RS-21-057

Braidwood Station, Units 1 and 2
Renewed Facility Operating License Nos. NPF-72 and NPF-77
NRC Docket Nos. STN 50-456 and STN 50-457

Subject: License Amendment to Braidwood Station, Units 1 and 2, Technical Specification 3.7.9, "Ultimate Heat Sink"

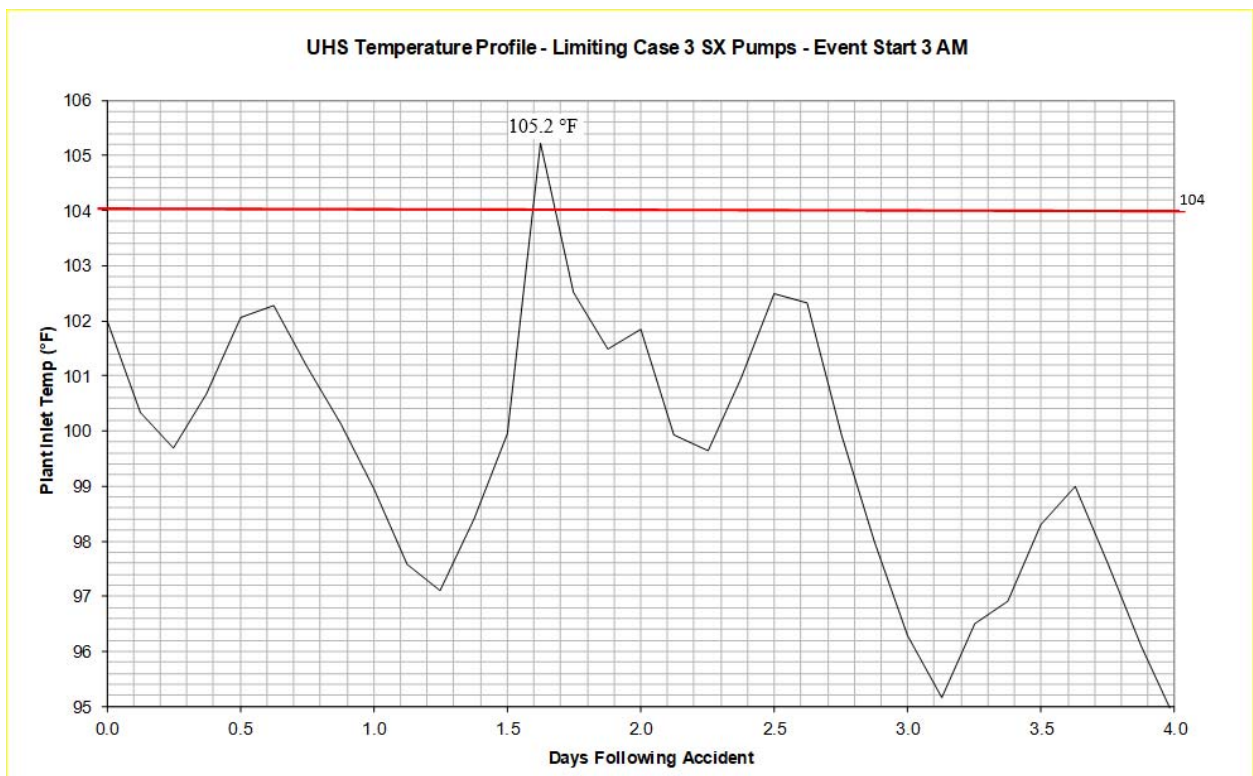
As discussed in the basis for TS amendments 189, EGC determined that with UHS starting at a temperature of 102°F, the highest UHS temperature during a worst case LOCA would be 105.2°F. The figure below shows the temperature response for this worst case LOCA at a start time of 0300. In support of TS amendment 189, EGC used 106°F to analyze the post-accident performance of the equipment served by SX except for the Reactor Containment Fan Coolers (RCFC) which used 104°F.
